ATTACHMENT C

PROJECT: Rockville Pike (MD355)/Center Drive /Jones Bridge Road Intersection
SHA Contract No. MO5935470
Mandatory Referral No. MR2010807

Proposed Configuration

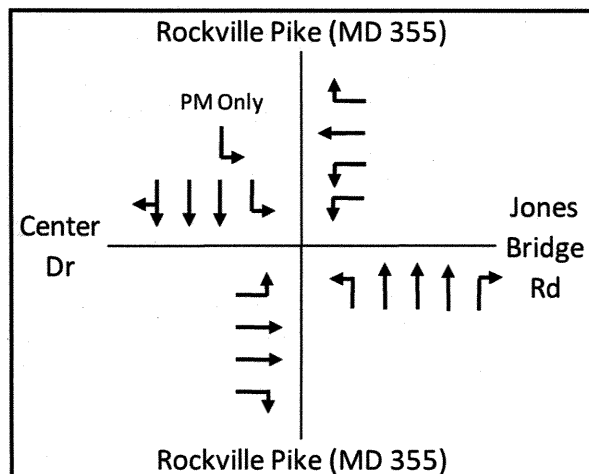
Intersection: No crosswalk would be provided on the north leg of the MD355/Jones Bridge Road intersection.

MCDOT proposes to construct a shared use path along the north side of Jones Bridge Road, a project that is scheduled to be reviewed by the Board on 7/15/10. This is reflected in SHA's plans. However, no crosswalk is currently proposed on the north leg of MD355, making the route very circuitous to get from the Jones Bridge path to the MD355 path headed north to the Metro or to other destinations. It would also be cumbersome to get from the same point into the NIH campus. The existing traffic island between the westbound right turns and the other Jones Bridge Road traffic carries a utility pole that SHA has said it would be very expensive to move. Retaining this unusual island makes it more complicated than most intersections to accomplish a north leg crosswalk, but this would be made easier if the curb radii were reduced.

We recommend that this north-leg crosswalk be included in this project.

The Master Plan recommends trees on both sides of Rockville Pike between the curb and sidewalk/path and in the median, but the proposed project has none. Very few shade trees are proposed and all are behind the proposed shared use path along NIH's frontage. All other landscaping is behind the sidewalk/path.
